Title - Sujet Const.Svcs, Westmorland Inst, N.B.	
Solicitation No. - N° de l'invitation EC016-132714/A	Amendment No. - N° modif. 008
Client Reference No. - N° de référence du client R.043939.001	Date 2013-01-25
GETS Reference No. - N° de référence de SEAG PW-\$PWB-020-3192	
File No. - N° de dossier PWB-2-35125 (020)	CCC No./N° CCC - FMS No./N° VME
Solicitation Closes - L'invitation prend fin at - à 02:00 PM on - le 2013-02-06	Time Zone Fuseau horaire Atlantic Standard Time AST
F.O.B. - F.A.B. Plant-Usine: <input type="checkbox"/> Destination: <input type="checkbox"/> Other-Autre: <input type="checkbox"/>	
Address Enquiries to: - Adresser toutes questions à: Donovan, Janine PWB	Buyer Id - Id de l'acheteur pwb020
Telephone No. - N° de téléphone (506) 636-5347 ()	FAX No. - N° de FAX (506) 636-4376
Destination - of Goods, Services, and Construction: Destination - des biens, services et construction:

Addenda numéro 8.

QUESTIONS ET RÉPONSES

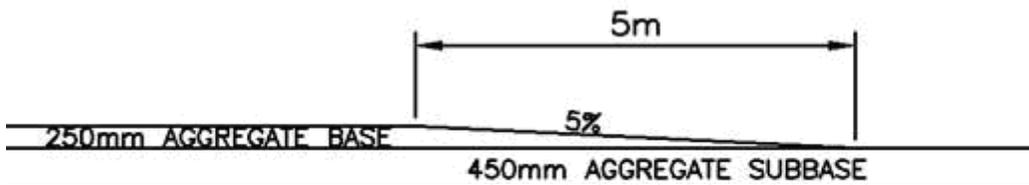
Q1: Drawing C200: There is an area to the South of the new building that does not clearly indicate how the Gravel Yard is built up, there is a space in between two indicated gravel yards at the grade break not clearly indicated if it is to have just the 450mm Sub-base or if it also has the 250mm Aggregate Base at this area in between.

R1: The space in between the two gravel yards is a transition from 250mm of aggregate base to zero. So the section in this area will have 450mm of aggregate subbase and 0-250mm of aggregate base. See Sketch:
